REQUEST FOR INFORMATION **DATE:** August 08, 2016 **NO.:** RFI-237

Project Name: 15051-Webster University Interdisciplinary Science Building Project No.: 15051

Subject: Lighting Clarifications

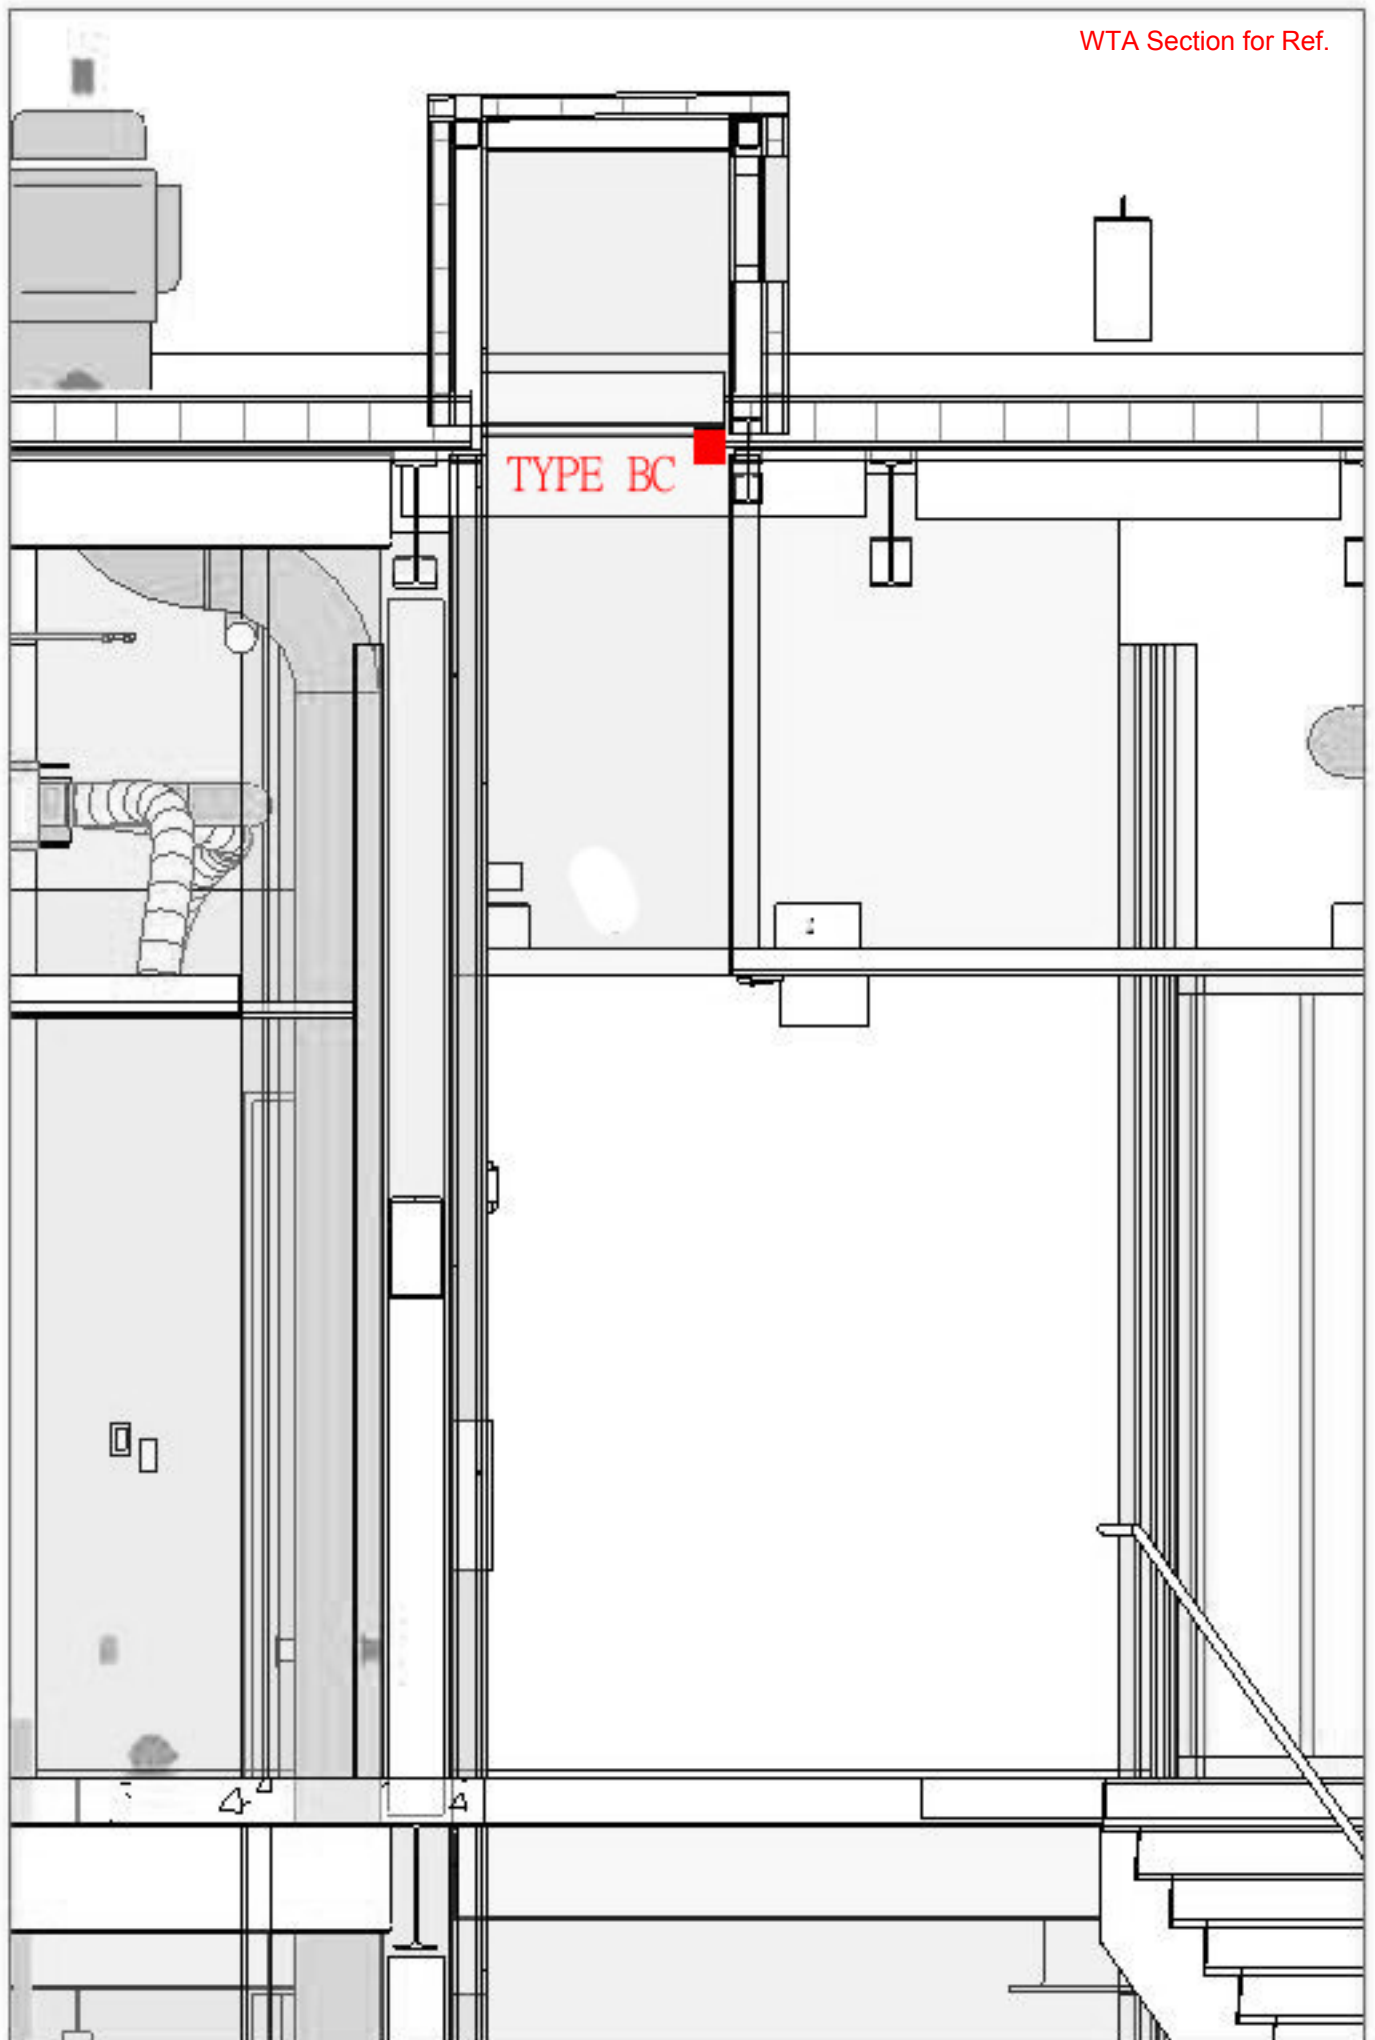
Type BC specified as wall mounted but seems to be off the wall. How is this fixture to be mounted? See sheet E0204.B.

Type BC: Fixture is wall mounted on skylight shaft wall, approximately 18' above 4th floor level, and is intended to illuminate the shaft and wall below. (See attached section for reference.)
